**Subject: EnergyConnect (NSW - Western Section) – SSI 10040**

## ATTACHMENT A BCD Assessment Summary for EnergyConnect (NSW – Western Section) Environmental Impact Statement (SSD 10040)

## **ATTACHMENT B Detailed comments for EnergyConnect (NSW - Western Section) Environmental Impact Statement (SSI 10040)**

Example of category 1 land mapped on Renmark Road roadside and Lot 5487/768396 that requires further justification (blue circle).

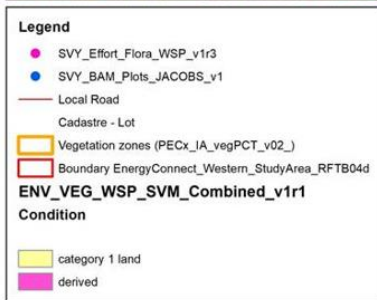
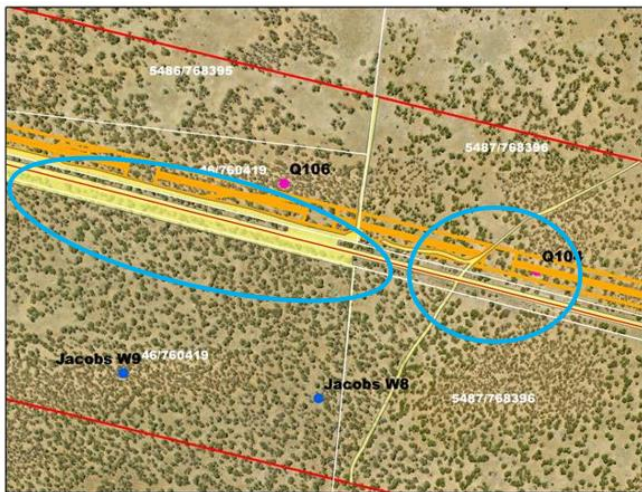
Some areas of naturally treeless vegetation have not been assessed. Assumptions about the impact of maintenance on biodiversity are not sufficiently explained to justify exclusion of these areas from the assessment.

For example: South Olary Plain sub-region (Lot 9, DP 1255309), mapped as PCT 154 Pearl Bluebush low open-shrubland in the vicinity of Jacobs flora plot W12. Jacobs ecologists described vegetation within this plot as in 'good condition'.

- the specific impacts of maintenance
- if maintenance includes regular vehicle movements across the vegetation
- if weed control is to occur within this area, and if so, what are the impacts on this vegetation and associated threatened species and their habitats?

- *Include areas where maintenance actions will occur in the impact area for the project or justify why ongoing maintenance activities will have **no** impact on biodiversity.*

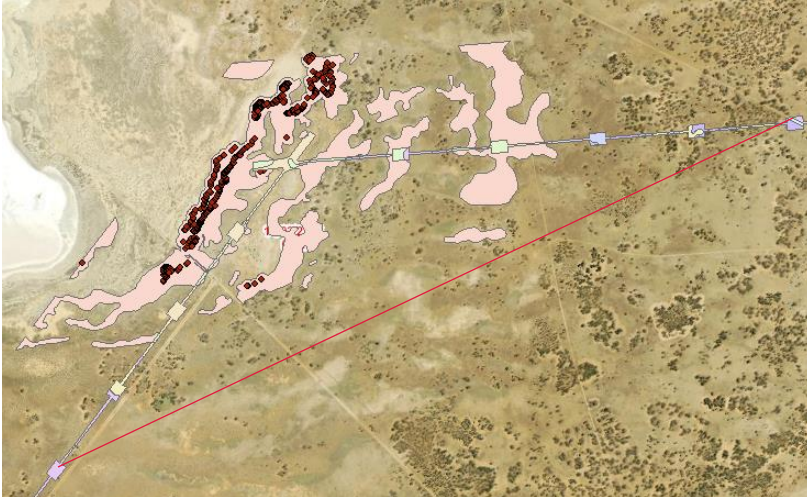
Table 9.14 provides an assessment of the SAI on *Austrostipa nullanulla*, following the *Guidance to assist a decision-maker to determine a serious and irreversible impact* (DPIE, 2019). The assessment addresses most of the SAI criteria.

However, the BDAR states that the proposal was refined to avoid and minimise impacts on *Austrostipa nullanulla*. In fact, there is an opportunity to completely avoid the gypseous rises that are habitat for this species by running the alignment south of this area (see figure below). The EIS does not explain why this option was not feasible.

- Explain why the project alignment cannot avoid the areas of habitat for *Austrostipa nullanulla*.

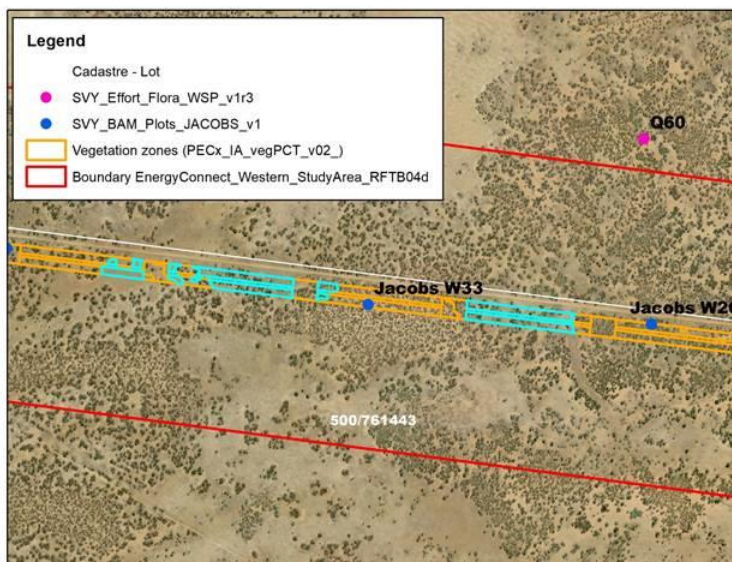
Derived native vegetation communities appear to have been over-estimated.

Derived vegetation is defined in the BDAR as vegetation lacking a canopy stratum (e.g. see PCT 56 page C2.32). This definition does not accord with the definition in the BAM Operational Manual (Stage 1, page 15) that derived (or secondary vegetation) is vegetation that has changed to an alternative stable state as a consequence of land management practices since European settlement. Derived PCTs differ from PCTs that have been modified from their natural state in that the derived PCT is unlikely to revert to the natural state without significant active restoration. Temporary loss of structural elements due to grazing, drought or fire may result in a vegetation with lower vegetation integrity than an intact example without being designated as derived.

It is incorrect to map the boundary of woodlands or open-woodland to the edge of obvious tree canopies. The structure of an open-woodland overstorey is defined as “well separated” trees with a crown cover of 0.25 to 20% (Walker & Hopkins 1990). The equivalent foliage cover is 0.2 - 10% (Table 17 in Hnatiuk *et al.* 2009). That means trees in a mapped woodland polygon can be 100 m apart.
